Addendum No. 1
May 30, 2023

Project: Dell Rapids City and Community Hall
317 E 4th ST Dell Rapids, South Dakota
Architecture Incorporated Project #2999

Architect: Architecture Incorporated

NEW POWER RISER DIAGRAM

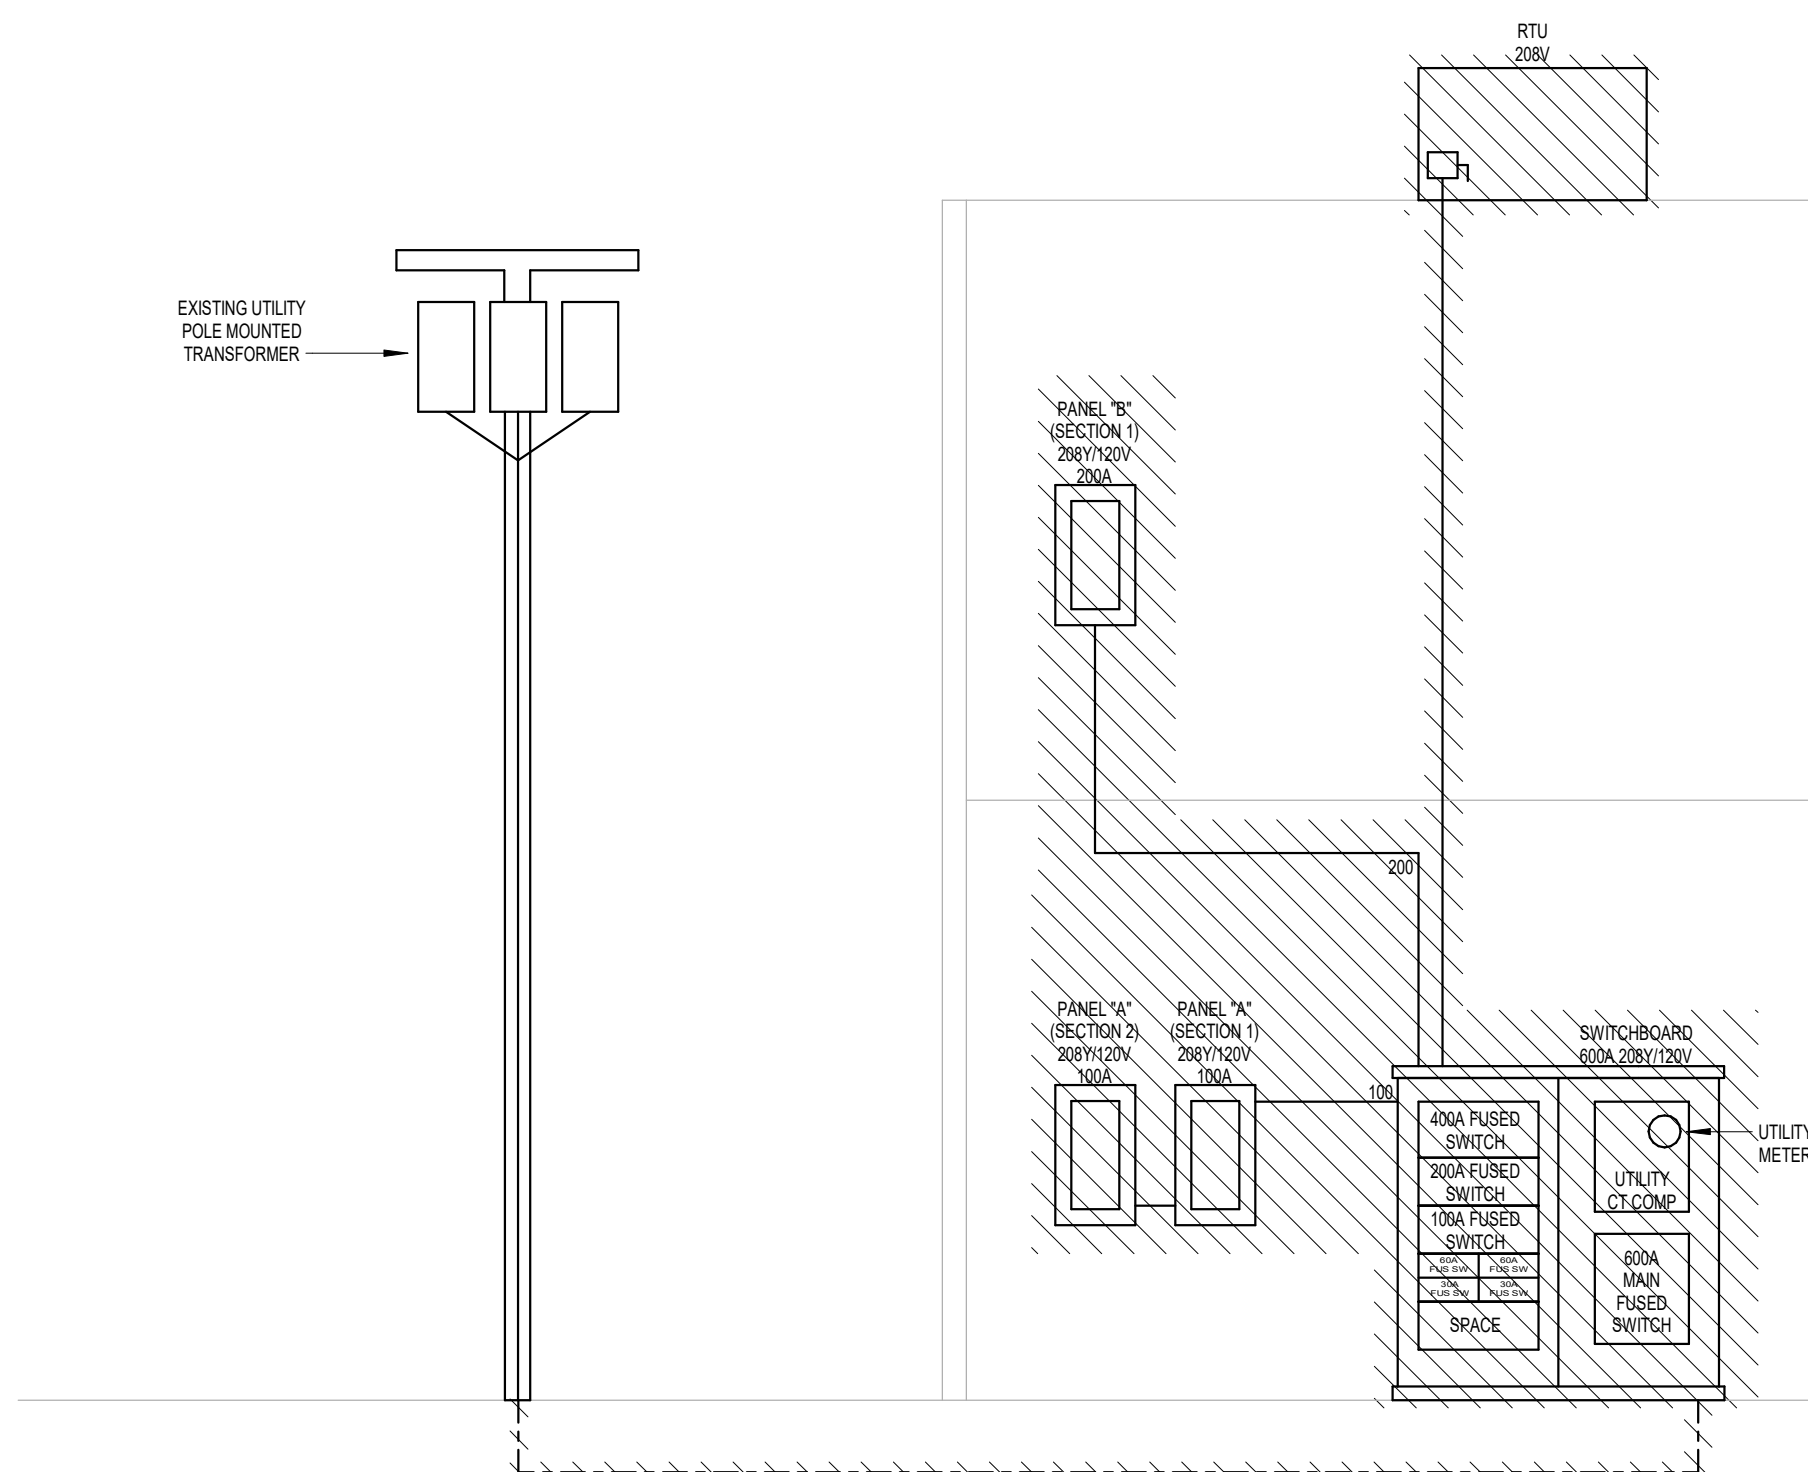
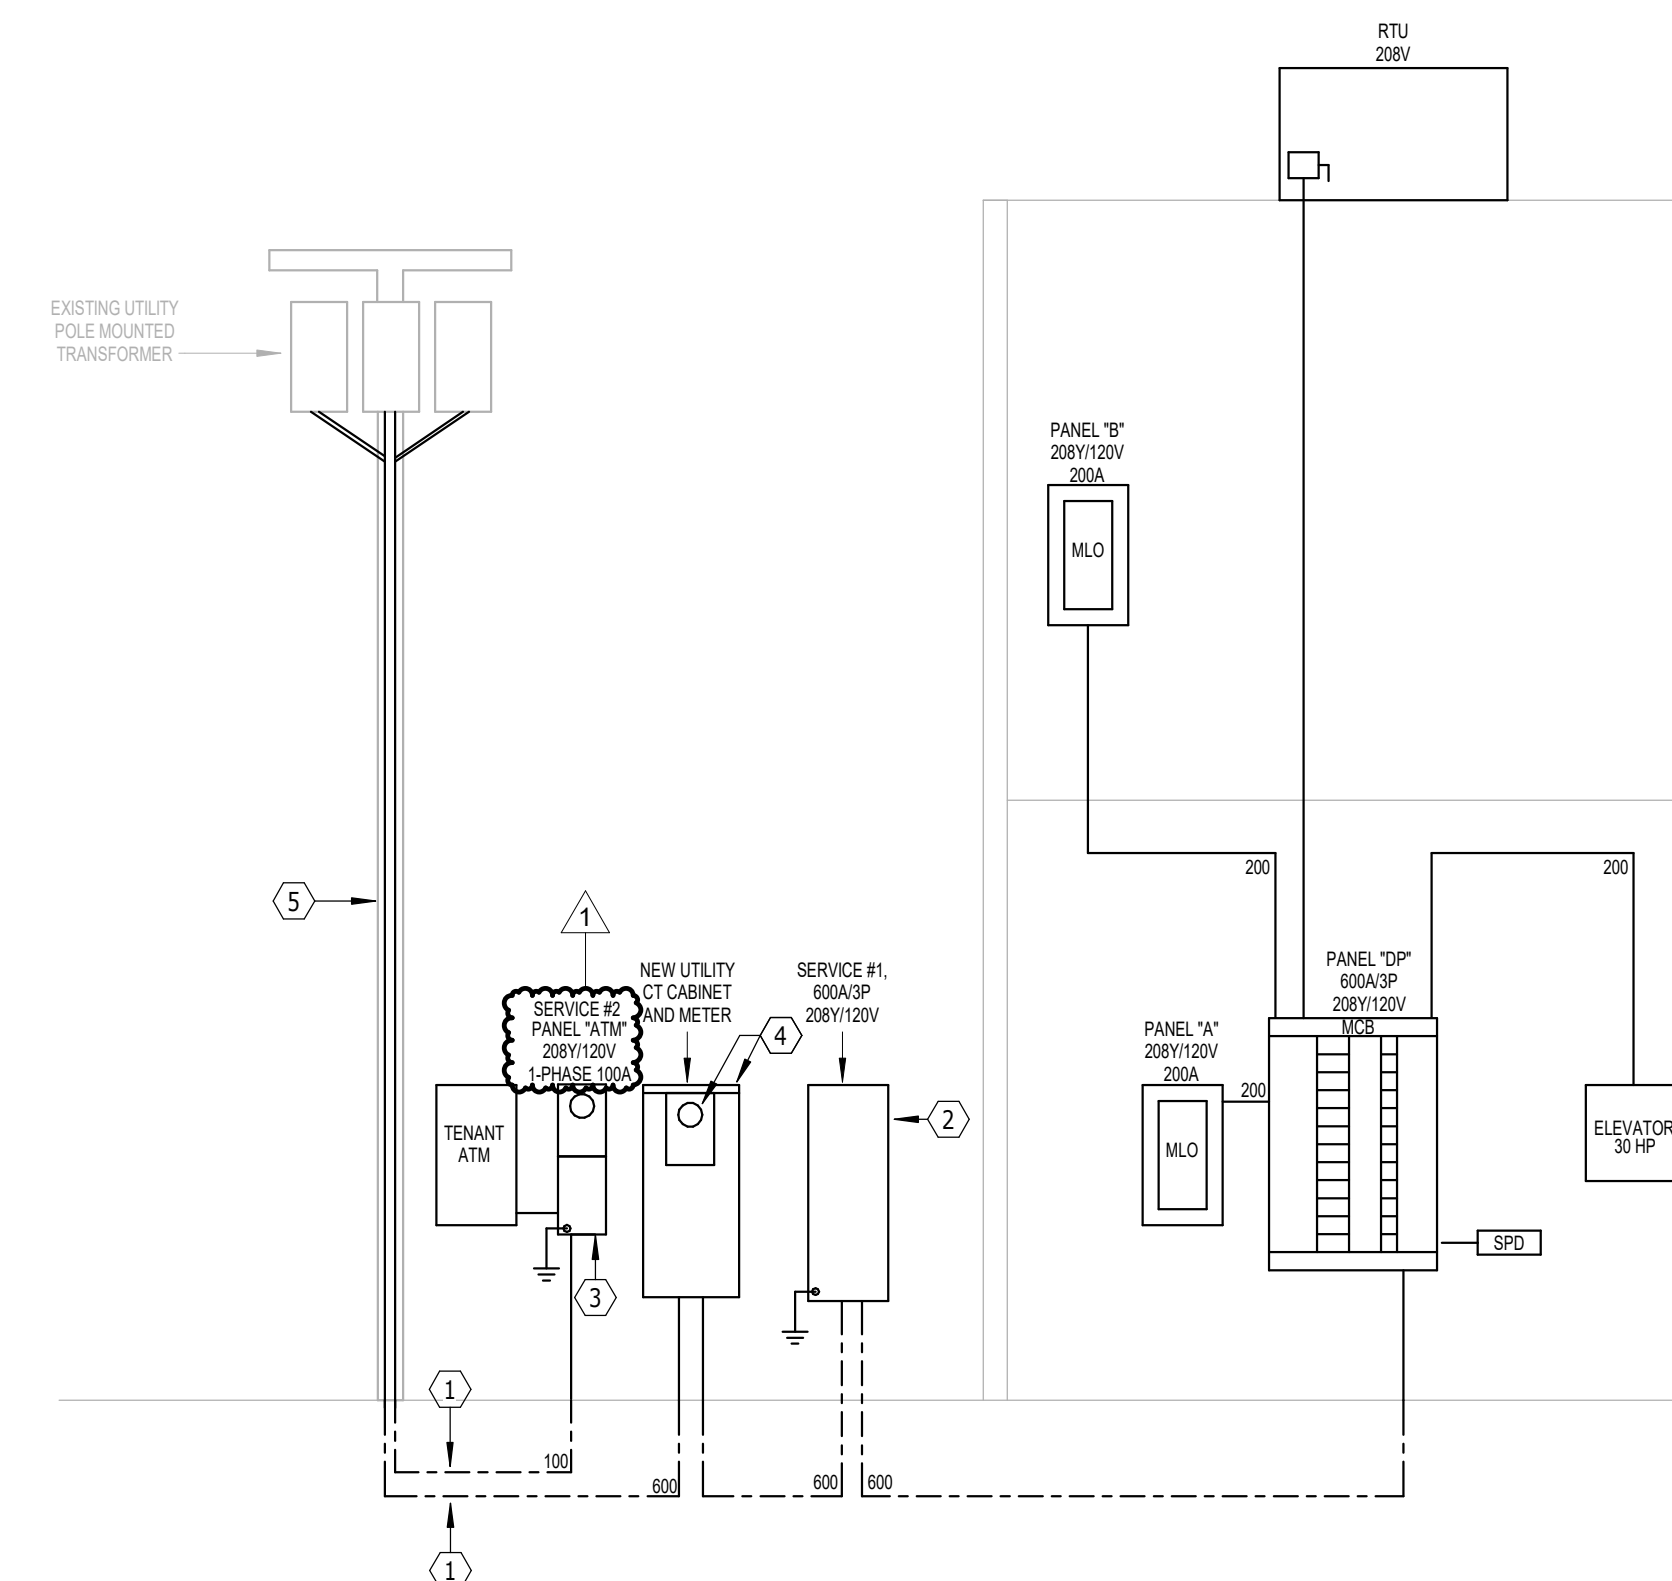
1. See updated Panelboard Schedules for Panelboards A, B and ATM.
2. Service #2 Panel (ATM) to be 100A, not 60A. See Revised Riser Diagram.
3. Supplemental factory drawings for Service #2 Equipment are attached below.
